UNITED STATES
NUCLEAR REGULATORY COMMISSION
WASHINGTON, D.C. 20555-0001

SUBJECT: TRIP REPORT - AUDIT OF BROWNS FERRY UNIT 3 USI A-46/IPEEE
IN-PROGRESS SEISMIC WALKDOWN, OCTOBER 16-20, 1995

BROWNS FERRY IN-PROGRESS SEISMIC WALKDOWN AUDIT REPORT

FIG B.1.1 (DG & IPS)
SEISMIC CAPACITY VS SEISMIC DEMAND
SPECTRA COMPARISON FOR DG AND IPS BLDG 5% DAMPING
1.5 X BOUNDING SPECTRUM (FIG 4-2 OF GIP) VS IN-STRUCTURE SSE RESPONSE

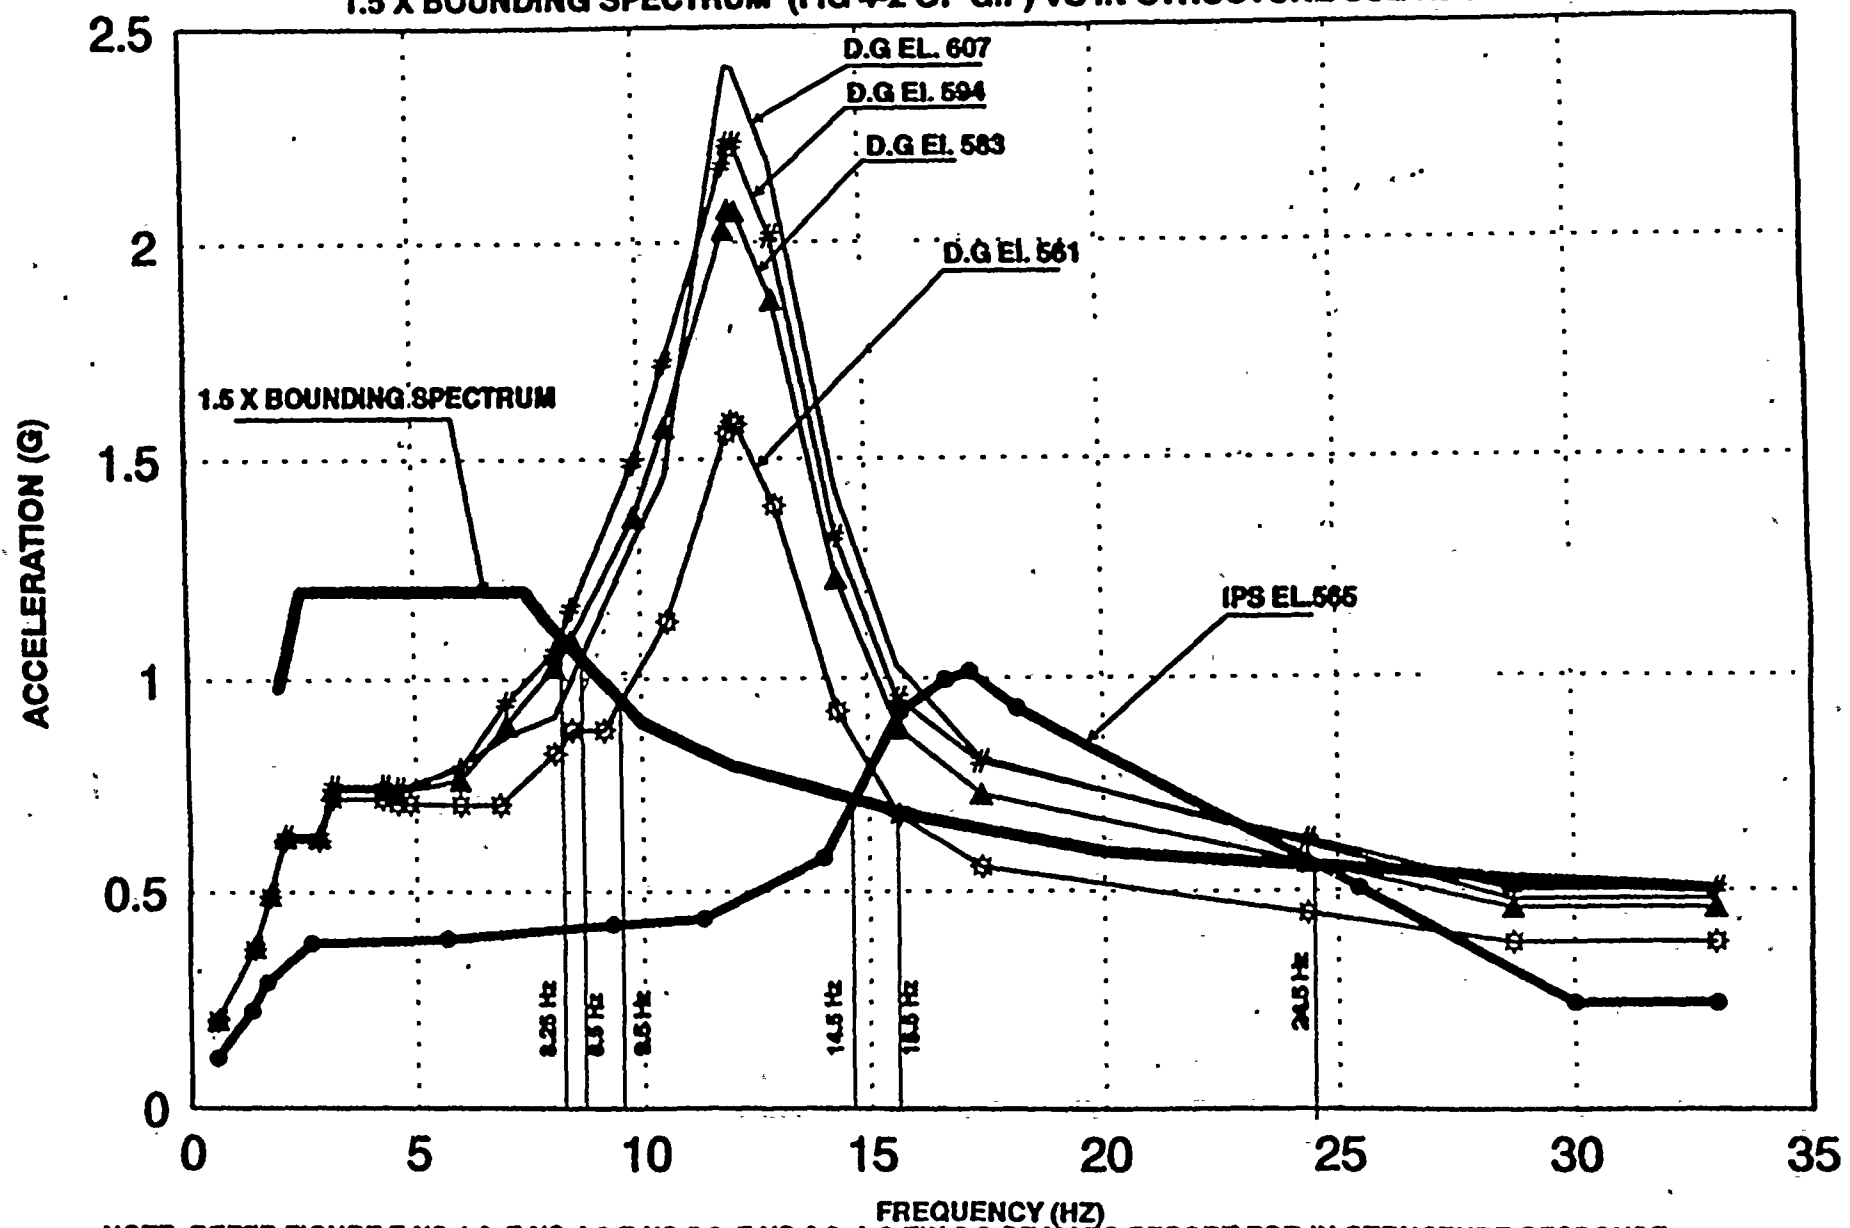
The Browns Ferry site SSE ground motion spectrum (approximately 0.3g spectral acceleration for a critical damping value of 5% and 0.2g ZPA) is substantially below the GIP-2 "Bounding Spectrum" (0.8g spectral acceleration for critical damping value of 5% and 0.33g ZPA). Therefore, in accordance with GIP-2, equipment items located at an elevation of up to 40-feet above effective grade may be adequate, provided that they satisfy the fundamental frequency requirement of about 8 Hz or higher. Alternatively, the GIP-2 also allows a comparison of the in-structure response spectrum with the equipment capacity spectrum, i.e., "Reference Spectrum." During the staff's audit, it was noted that if this second alternative is used, the licensing-basis seismic demands for some equipment items installed in the Diesel Generator (DG) Building and the Intake Pumping Station (IPS) will substantially exceed the "Reference Spectrum," i.e., the seismic demand measured by the in-structure response spectrum exceeds the seismic capacity of some equipment at certain elevations. Attachment 3 (Fig B.1.1), that was provided by the licensee during the audit, depicts curves representing seismic capacity vs. seismic demand for DG and IPS buildings. The figure signifies the magnitude of exceedence above the reference spectrum (1.5 x Bounding Spectrum) at various frequencies for various floor elevations in these buildings.

The staff does not consider the licensee's choice of the first alternative in the GIP-2 acceptable, since it results in a deviation from the licensing basis for the plant.

For Browns Ferry, it appears that the unexpected amplifications in-structure response spectra are due to large amplifications through the soil and the structures, especially at high frequencies for the DG Building and the IPS. In general, however, the staff contends that the use of the first method in the GIP-2 is only appropriate for facilities that do not have in-structure response spectra in their respective licensing basis documents. The staff believes that the lack of specificity in the GIP-2 with regard to the selection of the appropriate method for determining equipment seismic adequacy, has led to the identified non-conformance. The staff is pursuing this issue with the SQUG Steering Group.

In regard to the selection of the appropriate method to determine equipment seismic adequacy concerning seismic capacity compared to seismic demand, the staff finds the use of the first method in GIP-2 inappropriate in that it underpredicts the seismic demand for certain equipment as defined by the licensing basis in-structure response spectra. The staff believes the deviation was the result of inappropriate guidance in the GIP-2. The

potential inconsistency between the GIP-2 alternatives for determining equipment seismic adequacy and the licensing basis in-structure response spectra will be pursued with the SQUG Steering Group.
